**GE Hitachi Nuclear Energy**

MFN 09-670 Revision 1

Subject: **Revised Response to a Portion of NRC RAI Letter No. 368 Related to ESBWR Design Certification Application – Piping Design; RAI Number 3.12-3 S05**

**RAI Number 3.12-3 S05<sup>1</sup>**

**Figure B-3-5(a) Acceleration Time Histories for Vent Wall 701, and RPV Nozzle in N-S Direction from Time 7.5 sec. to 8.0 sec. (Not Correlated)**

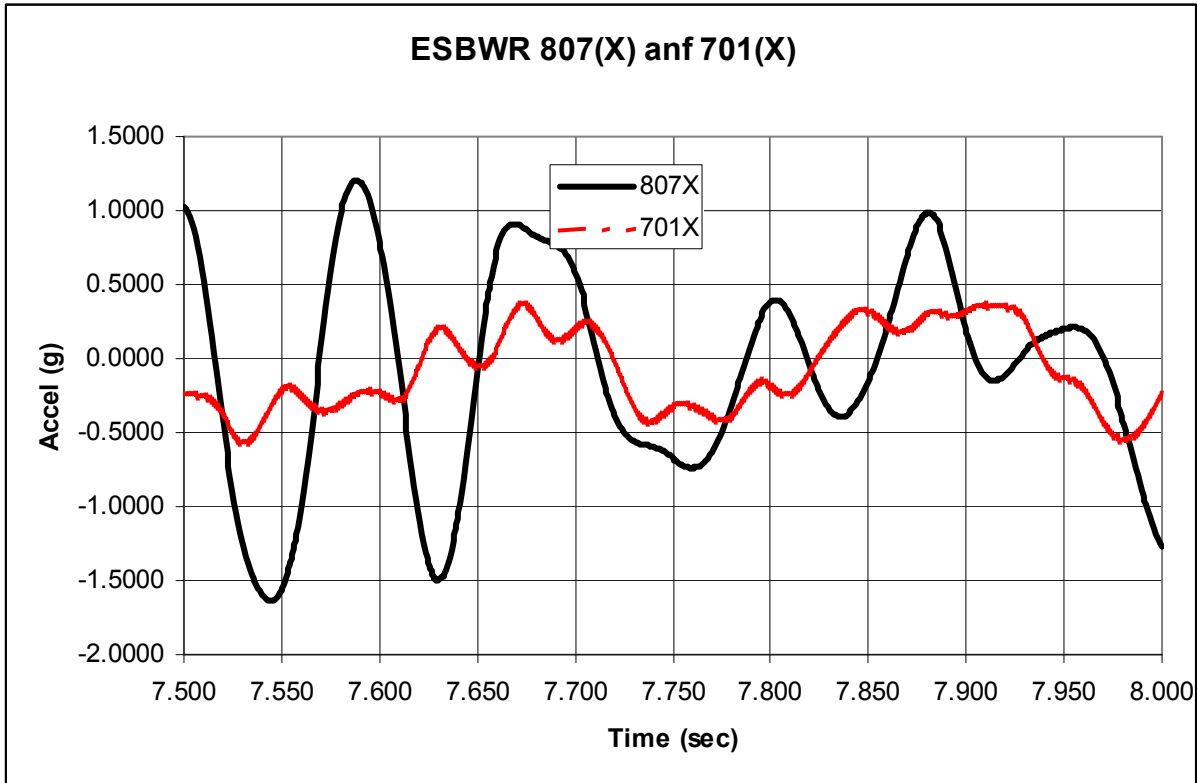
*The staff also notes that Figure B-3-5 of the GEH study report, MFN 06-119, Supplement 2, (ML072680480) showed phase correlation in the vertical direction. How does this justify the use of the SRSS method?*

Additional time histories plots for the RPV nozzle and vent wall in the horizontal directions, North-South (N-S) and East-West (E-W), are plotted to demonstrate that there will be no correlation in the horizontal direction when the piping is not supported by the same structure. These plots are presented with this RAI

The above four figures illustrate that in the horizontal direction the N-S and E-W time histories at the RPV nozzle and the vent wall are not correlated. Additional plots for Nodes 206 and 807 in the horizontal direction are also provided for reference. The necessary conditions to have correlated time histories are:

- (1) support points are on the same floor, that have exact the same mode shape and natural frequencies, or,
- (2) on the same concrete slab plus the member to the support points are rigid, such as the RPV wall and the vent wall are rigid in vertical direction.

Since the vertical direction for the cases evaluated in the study met these conditions, the comparison plots show that phase correlation was present, but since the other two directions were not correlated, the results of the study still demonstrates that the SRSS method was valid when the 10% adder was applied.
